Land at Hamble Airfield, Hamble-le-Rice

## HIGHWAY IMPACT REVIEW

for Sand and Gravel Extraction  
on behalf of Hamble Parish Council

2023/6992/HIR01

**Summary:** Pedestrians and cyclists are likely to travel along the existing verge

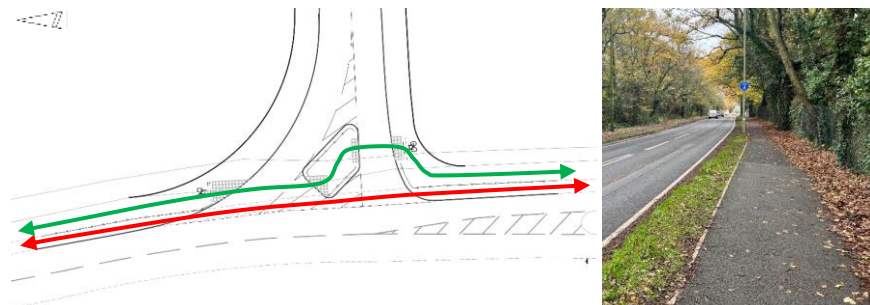
- 4.6.1 Problem A.4 'Pedestrians and cyclists are likely to travel along the existing verge' related to the suggestion that the deterrent paving is installed within the verge besides the proposed guardrailling which has been put to the LHA for consideration. It is RGP's recommendation that deterrent paving is installed.

Hamble Lane benefits from a shared footway cycleway along the eastern side of the carriageway that is offset from the carriageway by a one metre wide grass verge and allows access between The Hamble School to the north and Hamble-le-Rice to the south. As observed, the existing shared footway cycleway accommodates a high footfall particularly before and after the school day with users travelling along the grass verge as well as the footway cycleway. The proposals include the provision of a priority access off the eastern side of Hamble Lane. As part of the proposals, an uncontrolled crossing point is to be provided which benefits from a refuge island and guardrailing is to be installed to guide users towards the crossing point. It is though, however, that a number of pedestrians and cyclists will continue along the verge on the carriageway side of the guardrailing and attempt to cross the proposed junction along the edge of the Hamble Lane carriageway. Due to the seating position and eye height of a driver travelling in a Heavy Goods Vehicle, visibility in close proximity is very restricted and the Audit Team have concerns that a pedestrian or cyclist crossing in front of a Heavy Goods Vehicle will not be seen leading to a vehicle to cyclist / pedestrian collision.

<b>DESIGN ORGANISATION RESPONSE</b> provided by i-Transport on the 2 <sup>nd</sup> December '22 following formal issue of this Stage 1 Road Safety Audit on the 30 <sup>th</sup> November '22.	
Considered – There is potential to install deterrent paving to prevent the pedestrians and cyclists from using the verge and travelling on the wrong side of the pedestrian guard railing, if considered necessary by Hampshire County Council – the Local Highway Authority.	
<b>AUDITOR'S VIEW OF DESIGN ORGANISATION RESPONSE</b> dated 2 <sup>nd</sup> December '22	
<i>Confirmation that deterrent paving could be provided and will be further considered, addresses the road safety concern at this stage.</i>	
<b>A.5</b>	<b>TRAFFIC SIGNS, CARRIAGEWAY MARKINGS AND LIGHTING</b>
	<i>No Road Safety Concerns regarding TRAFFIC SIGNS, CARRIAGEWAY MARKINGS AND LIGHTING have been raised at this stage</i>

DRAWING No: ITB13040-SK-013	REV: -
-----------------------------	--------

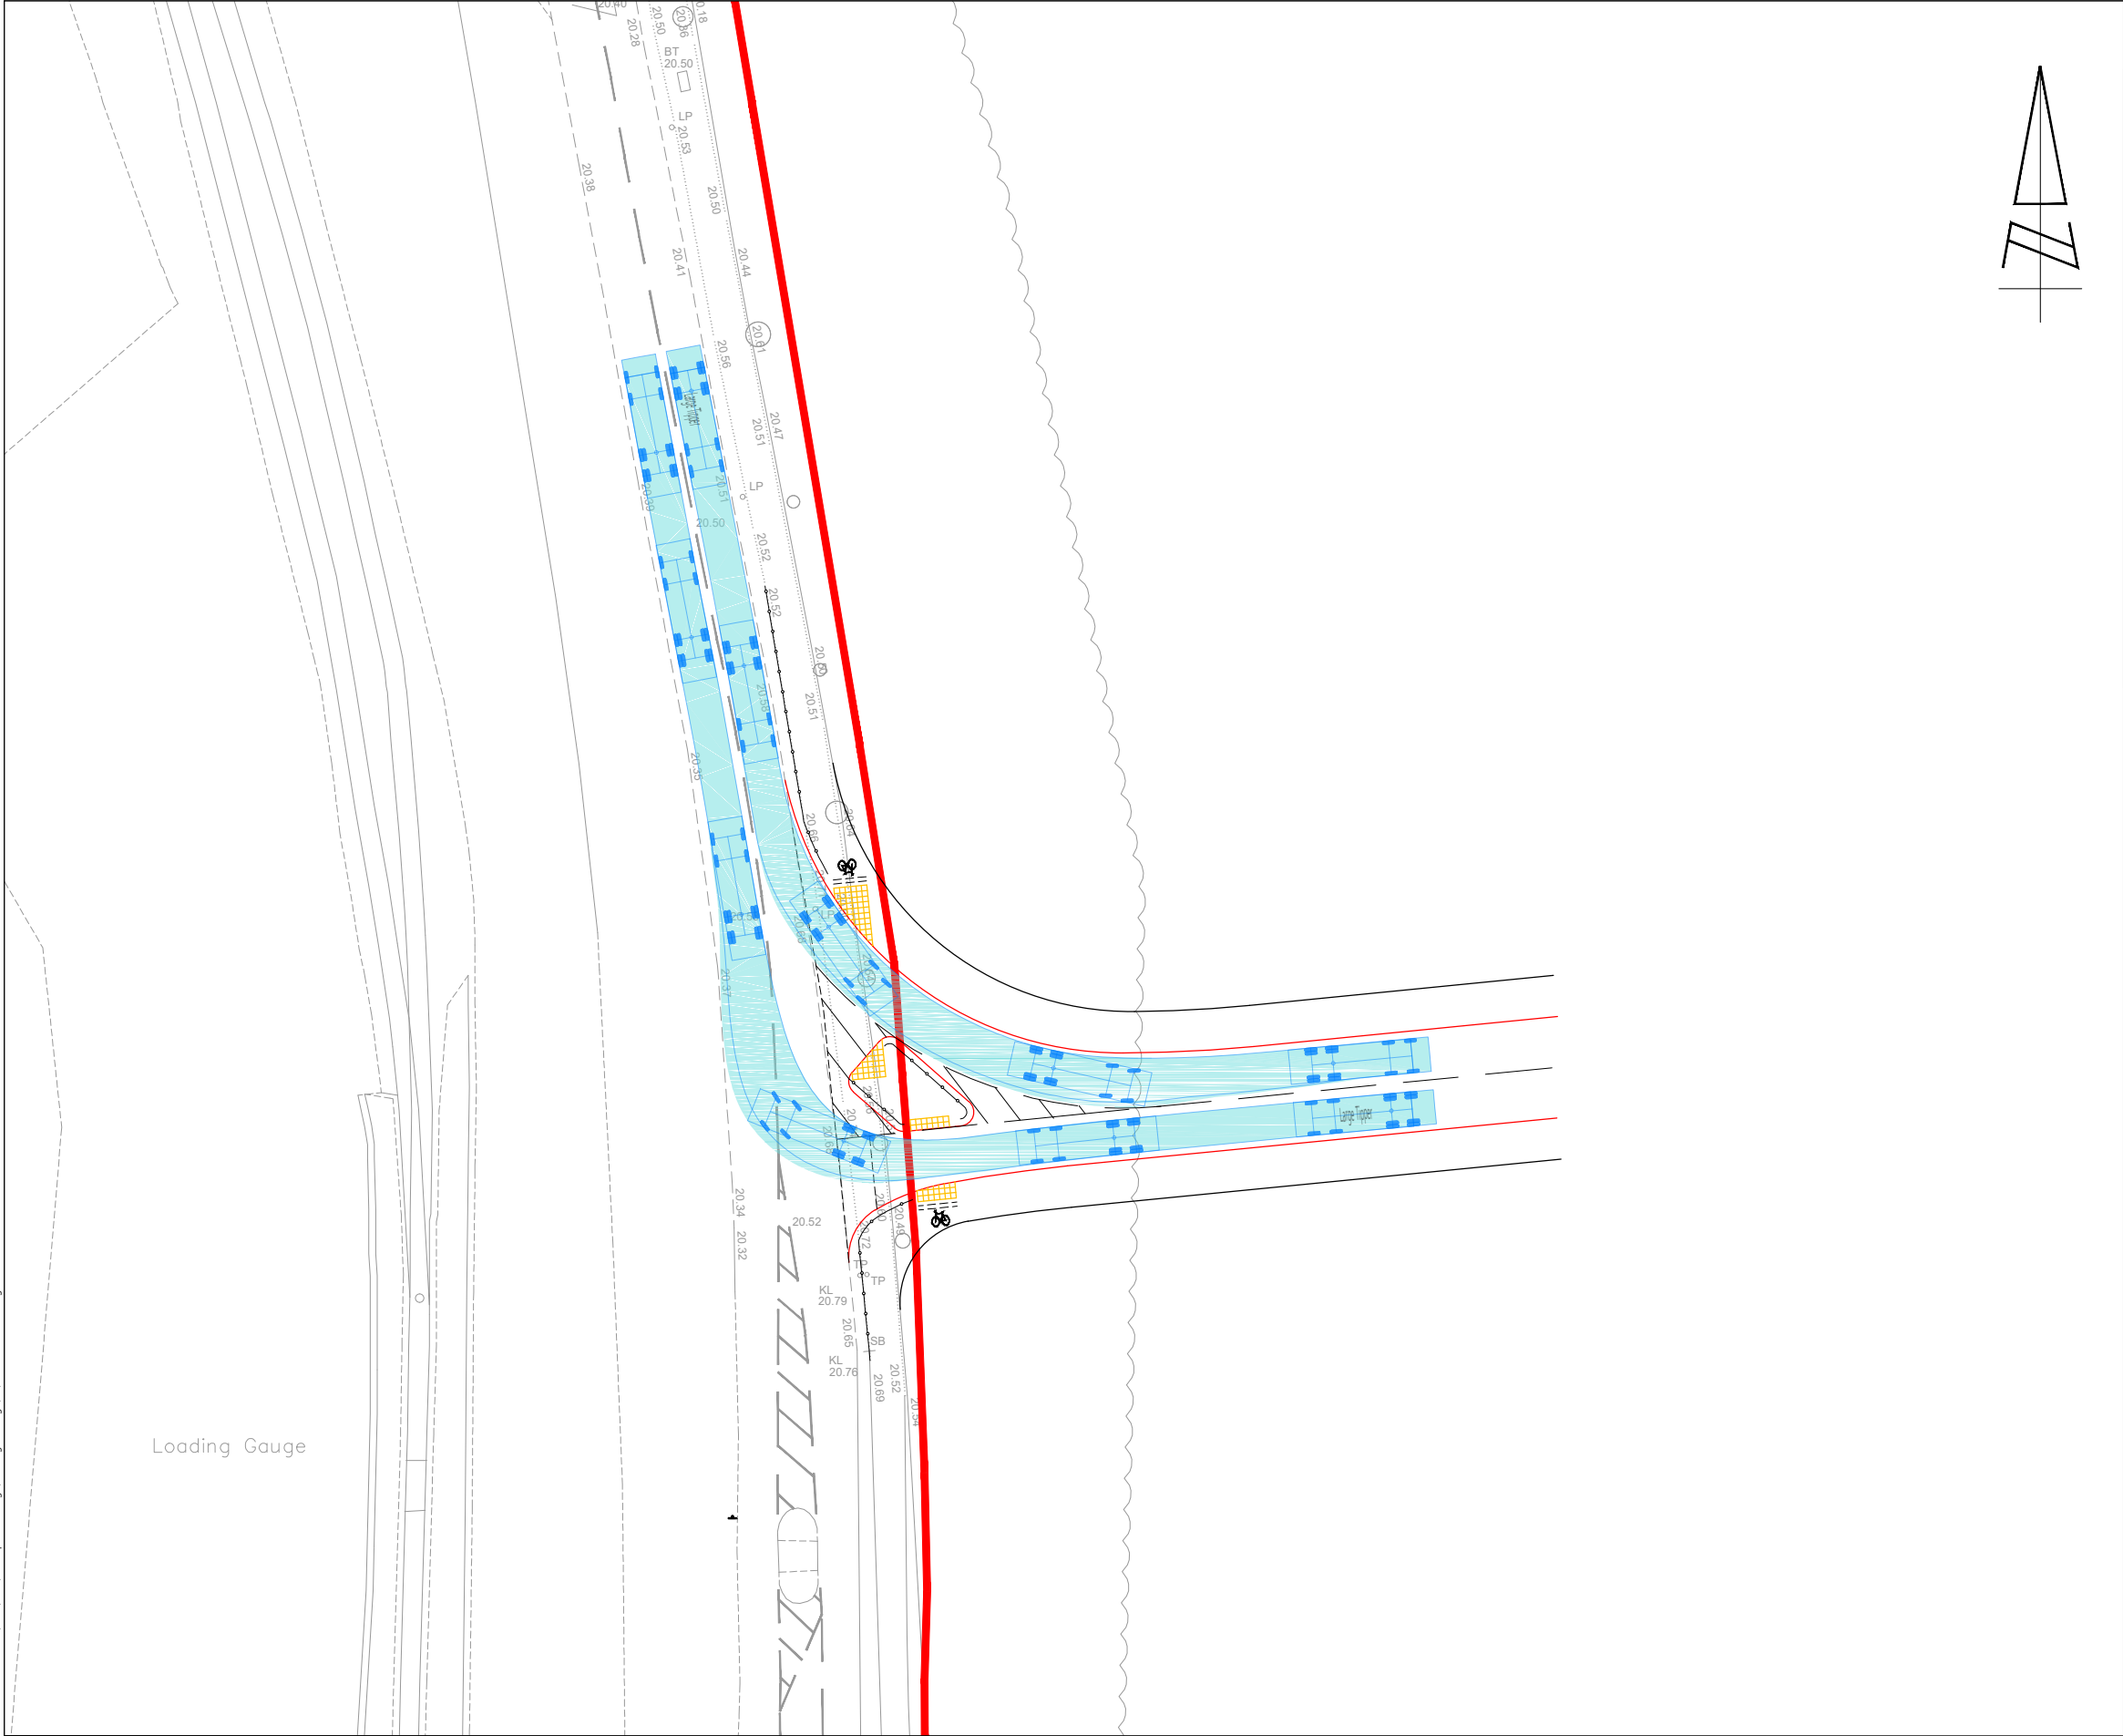
- 4.4.1 With reference to Problem A.2 '*Geometric parameters do not allow for even a small deviation from the swept path illustrated*' the auditors recommended that the geometric parameters of the proposed site access are increased to ensure adequate space for vehicle manoeuvres'.

- 4.4.2 The design audit response explained: '*Swept path analysis of the proposed access has been undertaken for a large tipper truck, as shown on drawing ITB13040-SK-013, which demonstrates that vehicles regularly anticipated to use the proposed site access junction can enter and egress the site safely*'. RGP are of the view that the manoeuvres shown are still incredibly tight and as the auditor explained leaves no margin for error.

- 4.4.3 The development proposals would result in 144 two-way HGV movements per day that as illustrated in the drawing would have to be conducted perfectly as any deviation from the path illustrated, would lead to HGVs encroaching onto the footway which could lead to a pedestrians/cyclist collision. RGP therefore do not consider that this matter has been adequately addressed.

Swept path analysis has been undertaken for a 16.5m long articulated vehicle to demonstrate the 'worst case scenario'. It is however envisaged that the majority of HGV movements to / from the site will be undertaken by 20 tonne rigid vehicles (which have an approximate length of 10 metres) with larger articulated vehicles only observed on a rare occasion. Swept path analysis of the proposed access has been undertaken for a large tipper truck, as shown on drawing ITB13040-SK-013, which demonstrates that vehicles regularly anticipated to use the proposed site access junction can enter and egress the site safely.
